# Differences Description

**Product:** CU155+

**Model Name:** A1232

**FCC ID:** O3YCU155PAPL

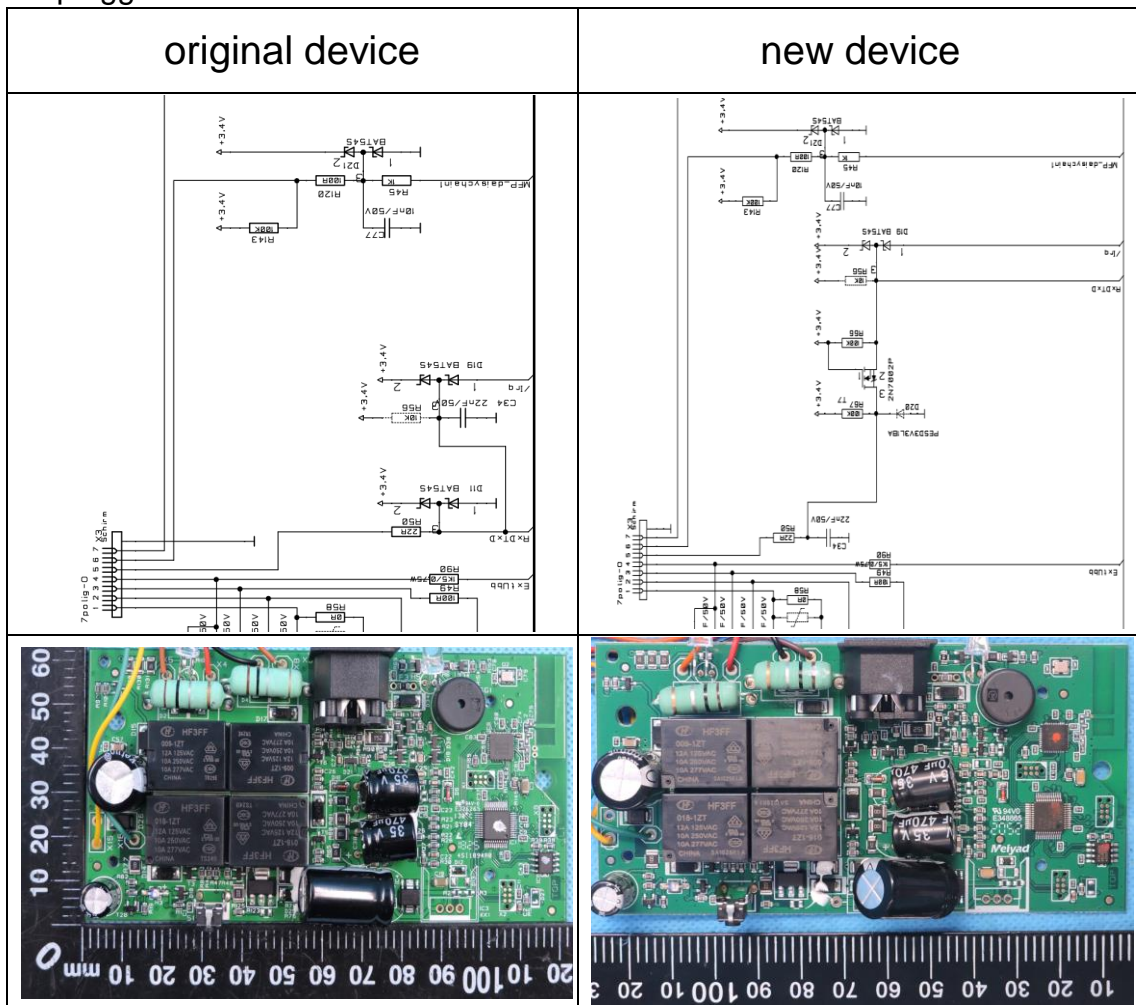
The new machine has changed the power supply circuit to reduce the probability of IC1 being burnt out when the MFP interface is plugged and unplugged.
